DEFINITE PROJECT REPORT (DPR)
WITH INTEGRATED ENVIRONMENTAL ASSESSMENT
LAKE CHAUTAUQUA

REHABILITATION AND ENHANCEMENT

LA GRANGE POOL
ILLINOIS WATERWAY
MASON COUNTY, ILLINOIS

The enclosed revised Finding of No Significant Impact (FONSI) and Clean Water Act Section 404(b)(1) Findings of Compliance (FOC) for the Lake Chautauqua, Illinois, Habitat Rehabilitation and Enhancement Project (R-7PR) is provided for your information.

**ALTERNATIVE D
SIDE CHANNEL EXCAVATION**

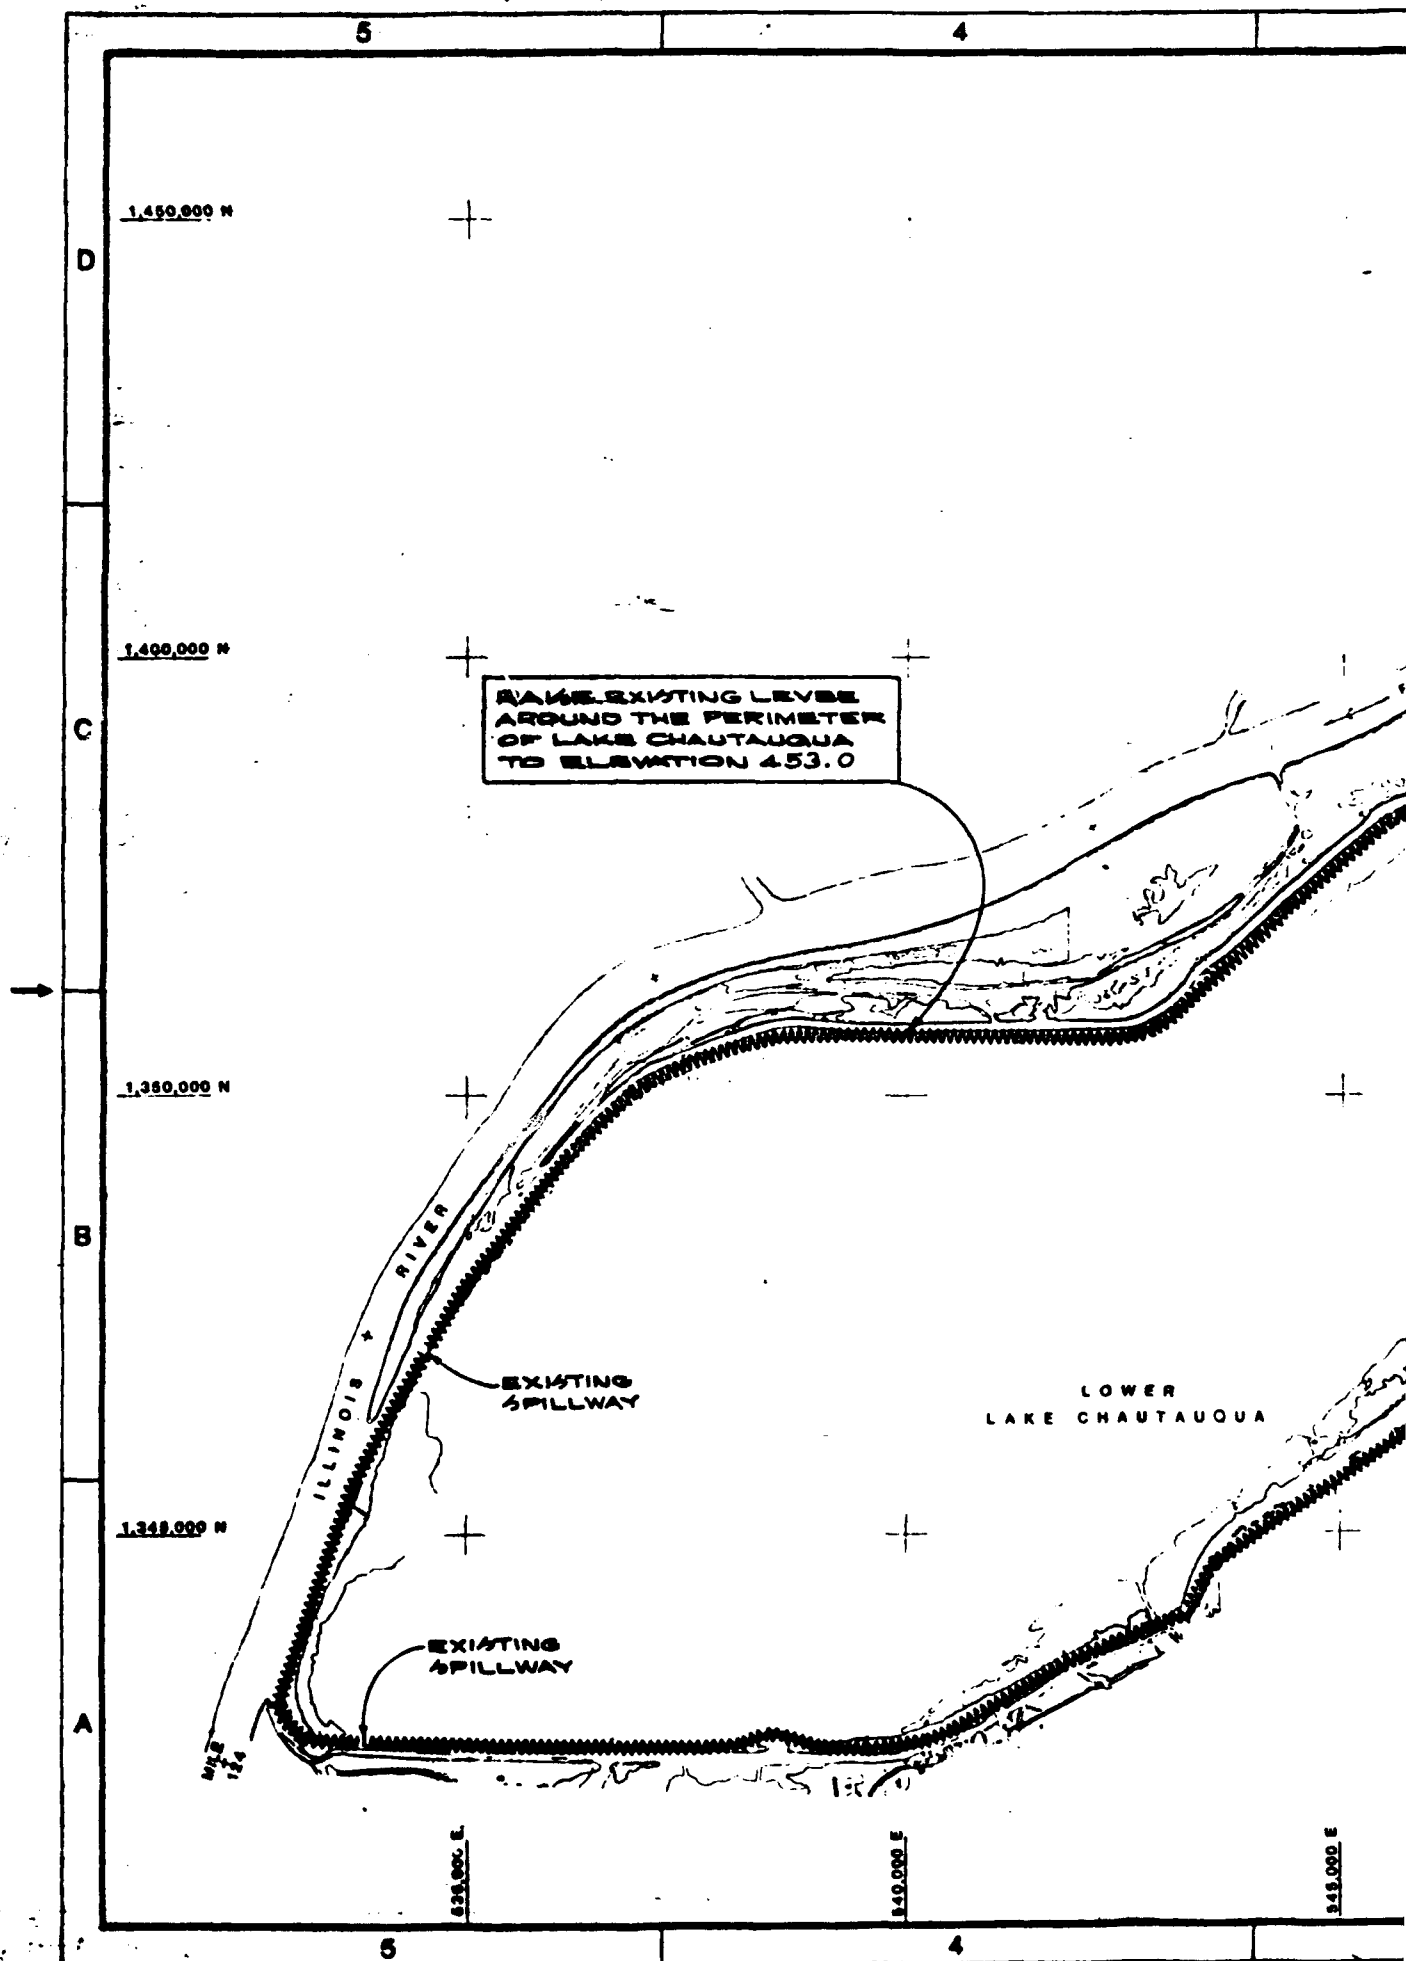
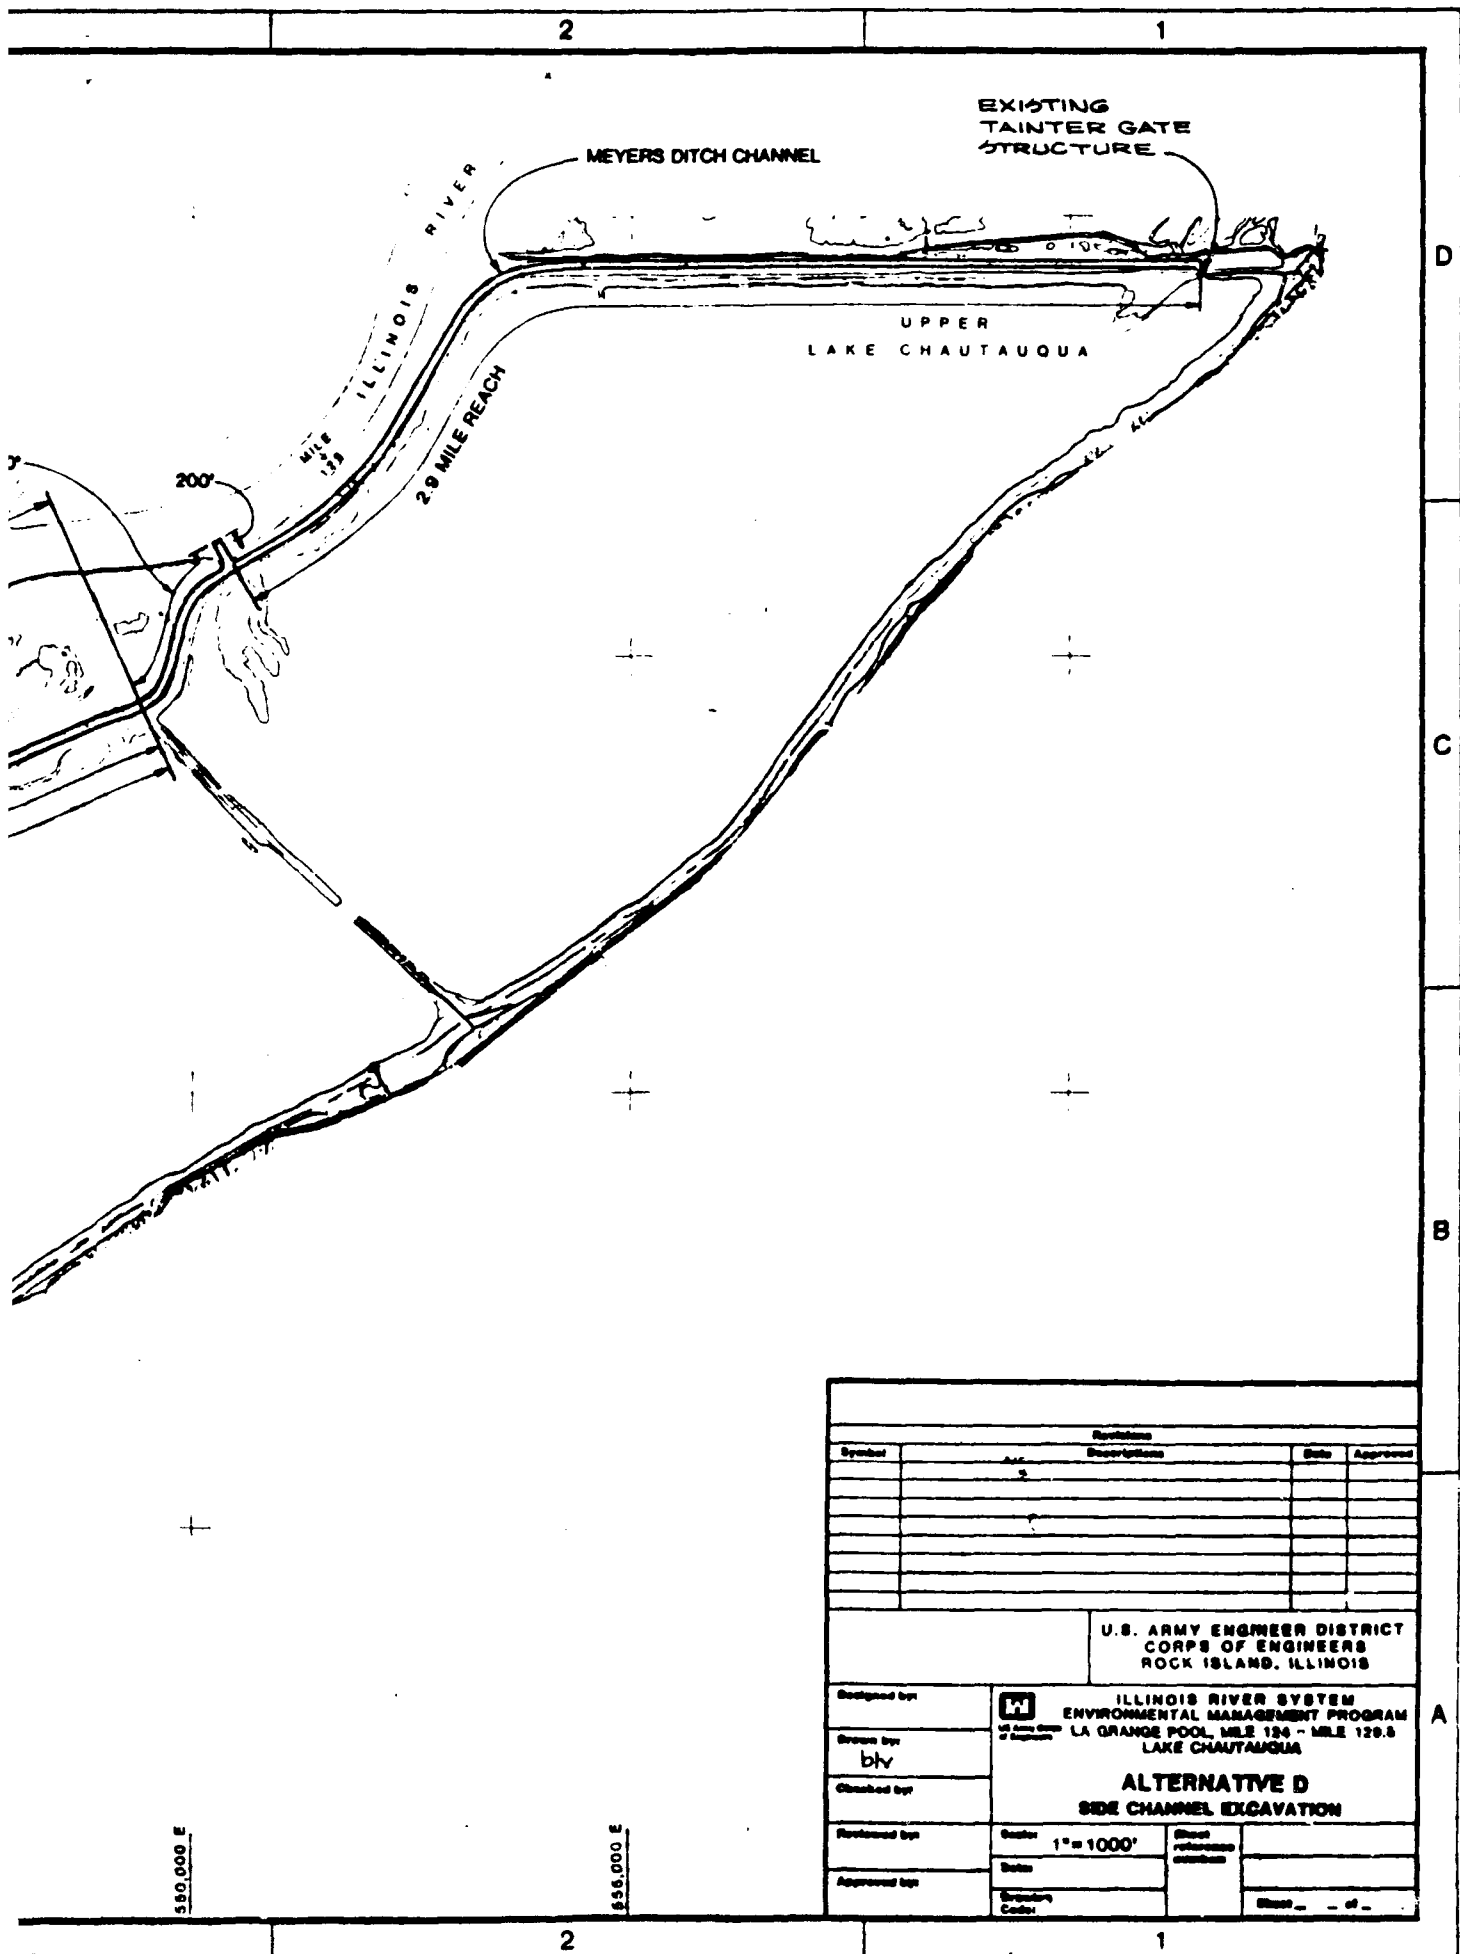
However, based on review by Corps higher authority, construction of flowing side channel and deep water slough habitat by excavation of the Liverpool Ditch has been deleted from the project. The decision to delete this element of the project was based on the lack of acceptable economic and habitat-based justification.

This FONSI is a revised version of a FONSI signed June 18, 1991. The Corps has determined that the Liverpool Ditch Cleanout element of this project does not have acceptable economical and habitat-based justification for construction. Therefore, those impacts as outlined in this report will not occur. Conversely, any benefits derived from this element will not occur as well.
